## REVISED PREFERRED PROJECT REPORT

MP08\_0207 and MP10\_0219

1, 1A and 5 Avon Road,  
4 and 8 Beechworth Road, Pymble

May 2013

FIGURE 1 – REORIENTATION OF BUILDING 5 AND BUILDING 3

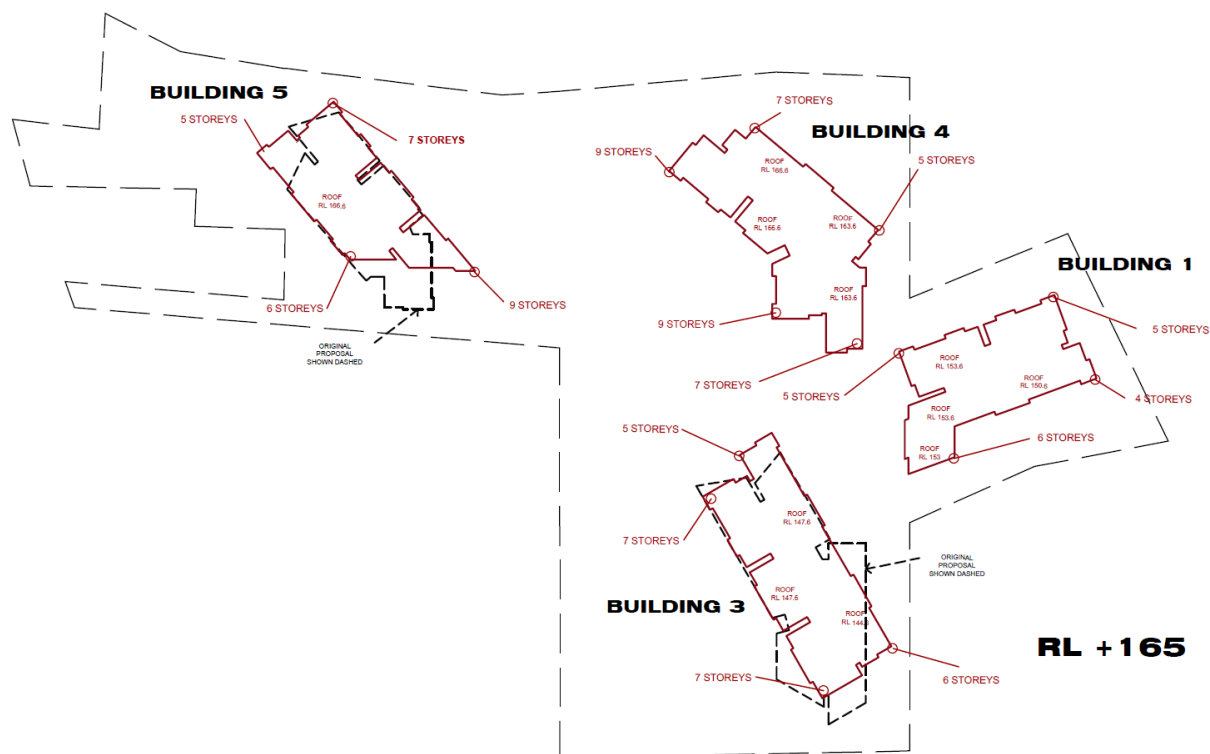
The envelopes of Buildings 3 and Building 5 are amended as shown in red below.

The eastern facing elevation of Building 3 has been realigned to face north-east to avoid direct overlooking of the rear of adjacent Avon Road properties. The amendments to Building 3 and the addition of skylights (a statement of commitment), means that this building now achieves 70% solar access and 70% natural ventilation as shown in **Appendix C**.

FIGURE 2 – BUILDING SEPARATION BETWEEN BUILDING 1 AND 3 AVON ROAD

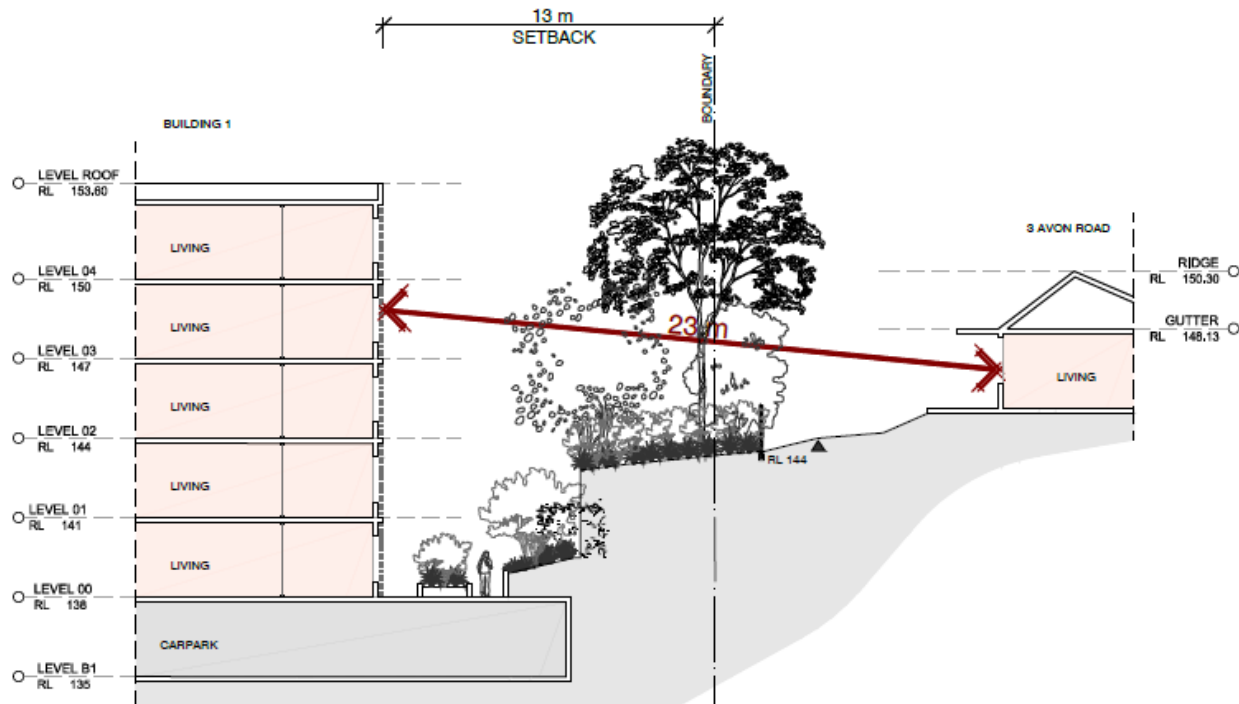
Confirmation of the physical separation between existing dwellings on adjoining properties and the proposed development (including basement footprints). The Department notes a number of anomalies between the information presented on the survey drawings and the Architectural and Landscape Plans – e.g. No.1 Arilla Road and No.15 Avon Road

- The south facing living room of Building 1 is setback 13m from the site boundary to the north and proposed Building 1 and 3 Avon Road are separated by a total distance of 23m.

- While Levels 3, 4 and 5 of Building 1 will have views to 3 Avon Road, the existing landscaping along the site boundary to 3 Avon Road consists of large trees and shrubs which are proposed to be retained and reinforced with new planting within the site. This existing and proposed planting will significantly mitigate the potential privacy intrusion from the three levels of Building 1 with views to 3 Avon Road.

Notwithstanding the above, to further mitigate potential overlooking, fixed opaque louvers are proposed along the windows of the apartment to the north east as shown in Figure 3 below. This will direct the outlook from apartments adjacent to No 3 Avon Road away from the primary living areas of the dwelling house at 3 Avon Road.

FIGURE 14 – PROPOSED DEEP SOIL ZONES

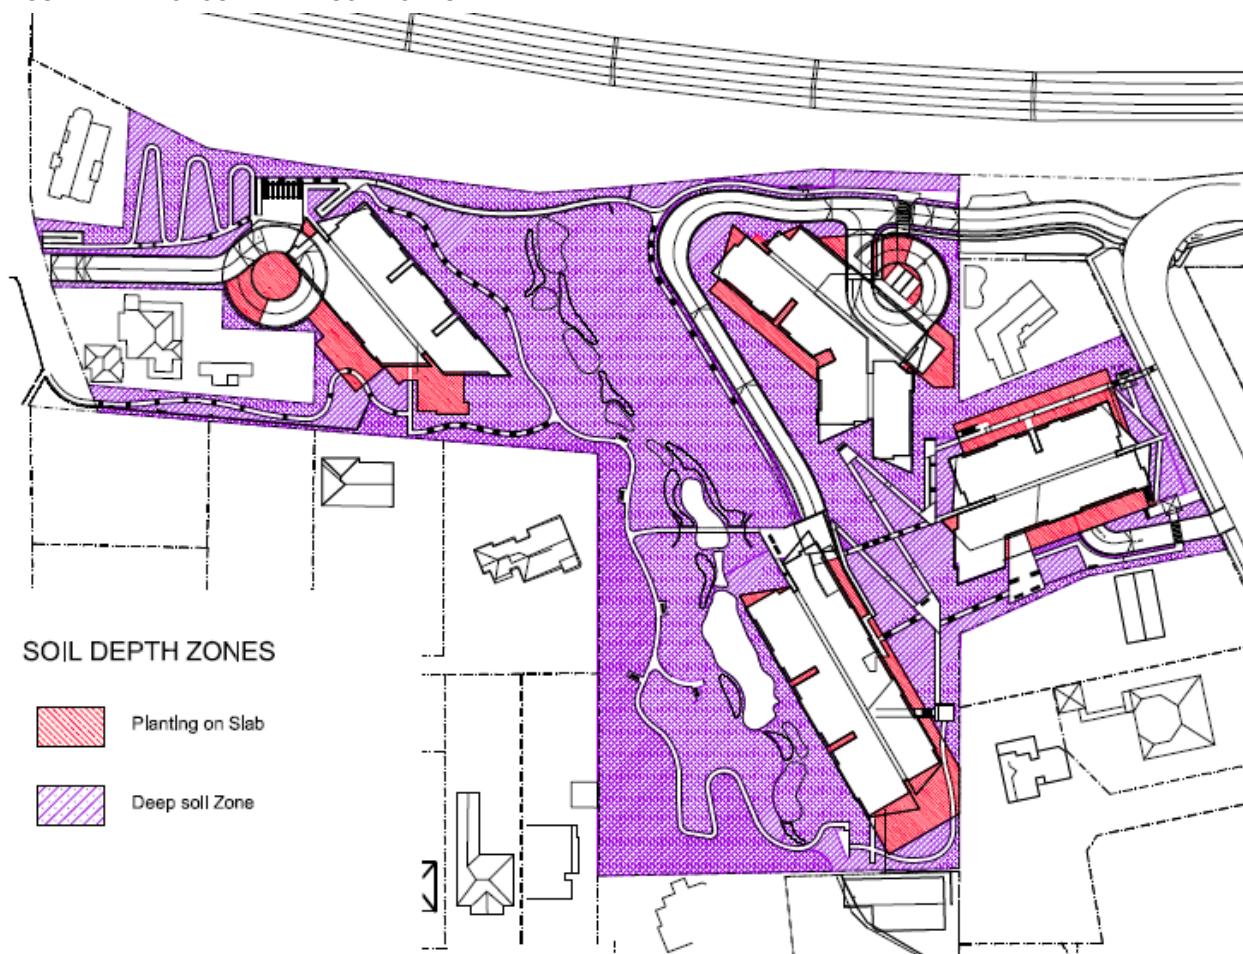
The basement of the Stage 1 building significantly encroaches into the Avon Road setback / deep soil zone. The Department concurs with Ku-ring-gai Council’s concern in this regard and it is requested that the basement be reconfigured to provide a more generous dimension between the basement and the Avon Road boundary to increase the area of deep soil and contribute to the garden setting which is characteristic of this locality.

The basement level of Building 1 has been reduced to accommodate increased deep soil zones along Avon Road. The proposed deep soil zone areas are shown in Figure 14.

The area is proposed to be landscaped by mature trees such as the transplanted Gordonia tree and Cocus and Phoenix Palms will provide a high quality established streetscape landscape character
